APPLICATION NO.	FILING DATE	FIRST NAMED INVENTOR	ATTORNEY DOCKET NO.	CONFIRMATION NO.
10/594,592	09/28/2006	Pierluigi Oresti	296853US6X PCT	5570
22850	7590	11/24/2008		
OBLON, SPIVAK, MCCLELLAND MAIER & NEUSTADT, P.C. 1940 DUKE STREET ALEXANDRIA, VA 22314				
EXAMINER				
SHUMATE, ANTHONY R				
ART UNIT		PAPER NUMBER		
1797				
NOTIFICATION DATE		DELIVERY MODE		
11/24/2008		ELECTRONIC

# Office Action Summary

## **DETAILED ACTION**

fig. 1.

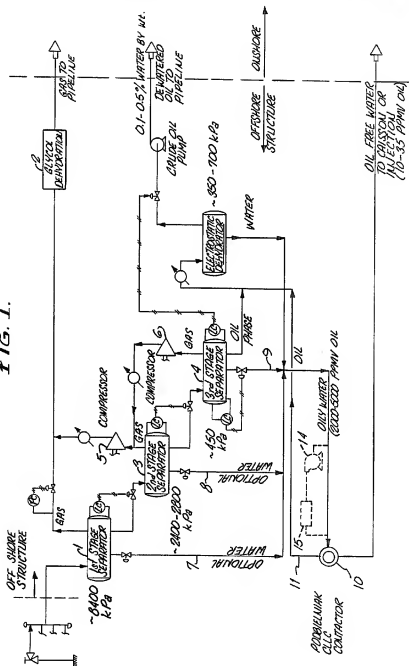
In addition for instant **claims 15-19**, SANDS et al. does not teach delivering the light hydrocarbon gases, separated in the high pressure separation stage, to a reinjection gas compression unit having at least two compression stages. AAREBROT et al. teaches at page 1 lines 15-20, page 4 lines 1-30, figure 1, and figure 2 delivering oil associated gases (light hydrocarbon gases), to a reinjection gas compression unit having at least two compression stages (C<sub>1</sub>-C<sub>5</sub>). It would have been obvious to one having ordinary skill in the art at the time the invention was made to process the petroleum (oil) gas of SANDS et al. with the reinjection system of AAREBROT et al., in order to retain the pressure of the reservoir in order to facilitate the oil recovery as taught by AAREBROT et al. at page 1 lines 15-20.

For instant **claim 20**, SANDS et al. does not teach wherein each stage of compression of the reinjection gas compression unit comprises at least a biphasic separator to remove liquid particles, a compressor, and a heat exchanger to cool the compressed gas. But, AAREBROT et al. teaches at the abstract, page 1 lines 15-20, page 4 lines 1-30, page 2 lines 25-32, figure 1, and figure 2 wherein each stage of compression ( $C_1$ - $C_5$ ) of the reinjection gas compression unit comprises at least a condensed water separator (biphasic separator to remove liquid particles)(U), a compressor ( $C_1$ - $C_5$ ), and a intercooler (heat exchanger)( $K_2$ - $K_6$ ) to cool the compressed gas. It would have been obvious to one having ordinary skill in the art at the time the invention was made to process the petroleum (oil) gas of SANDS et al. with the reinjection system of AAREBROT et al., in order to retain the pressure of the reservoir in order to facilitate the oil recovery as taught by AAREBROT et al. at page 1 lines 15-20.

For instant **claim 23**, SANDS et al. does not teach wherein the reinjection gas compression unit includes three compression stages. But, AAREBROT et al. teaches at the abstract, page 1 lines 15-20, page 4 lines 1-30, page 2 lines 25-32, figure 1, and figure 2 wherein the reinjection gas compression unit includes

three compression stages ( $C_1$ - $C_3$ ). It would have been obvious to one having ordinary skill in the art at the time the invention was made to process the petroleum (oil) gas of SANDS et al. with the reinjection system of AAREBROT et al., in order to retain the pressure of the reservoir in order to facilitate the oil recovery as taught by AAREBROT et al. at page 1 lines 15-20.

For instant **claim 26**, SANDS et al. does not teach wherein the recompressed gases exiting the compression units are sent to the reinjection gas compression unit. AAREBROT et al. teaches at page 1 lines 15-20, page 4 lines 1-30, figure 1, and figure 2 delivering oil associated gases (light hydrocarbon gases), to a reinjection gas compression unit having at least two compression stages ( $C_1$ - $C_5$ ). It would have been obvious to one having ordinary skill in the art at the time the invention was made to process the petroleum (oil) gas of SANDS et al. with the reinjection system of AAREBROT et al., in order to retain the pressure of the reservoir in order to facilitate the oil recovery as taught by AAREBROT et al. at page 1 lines 15-20.

Fig. 2.

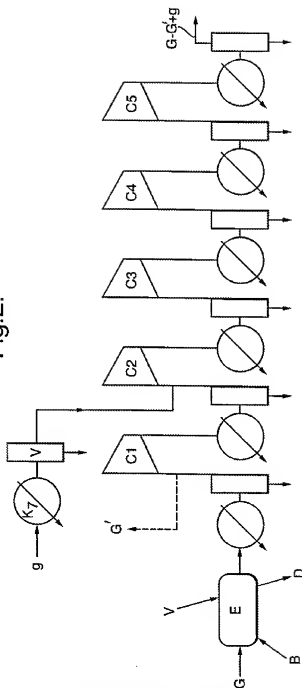
compression unit taught by AAREBROT et al. Furthermore, AAREBROT et al. teaches at the abstract, page 1 lines 15-20, page 4 lines 1-30, figure 1, figure 2 the reinjection gas compression unit produces exhaust.

4,339,917

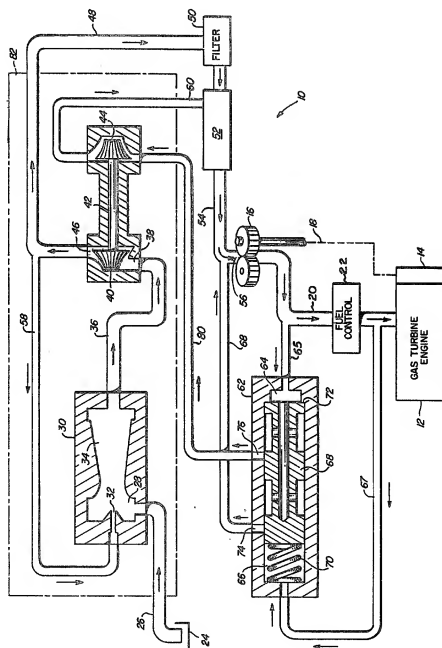
Also for instant **claims 15-19**, LAGRONE teaches the technique at column 1 lines 45-68, column 2 lines 15-50 and figure 1 **(2)** the compressed gas exiting from the last (one of) compression stages of the centrifugal pump (compression unit) as the fluid directed to (driving fluid) the ejector. AAREBROT et al. teaches at page 1 lines 15-20, page 4 lines 1-30, figure 1, figure 2 using a reinjection gas compression unit as discussed above for the obviousness to one of ordinary skill in the art of in order to retain the pressure of the reservoir in order to facilitate the oil recovery. Also, the (compression unit) taught by LAGRONE is similar to the

For instant **claims 21 and 22**, SANDS et al. does not teach wherein (1) the compressed gas to be used as driving fluid is taken below the compressor (2) before the cooling heat exchanger. But, LAGRONE teaches the technique at column 1 lines 45-68, column 2 lines 15-50 and figure 1 wherein the compressed gas to be used as directed fluid (driving fluid) is taken below the centrifugal pump (compressor). AAREBROT et al. teaches at page 1 lines 15-20, page 4 lines 1-30, figure 1, figure 2 using a reinjection gas compression unit as discussed
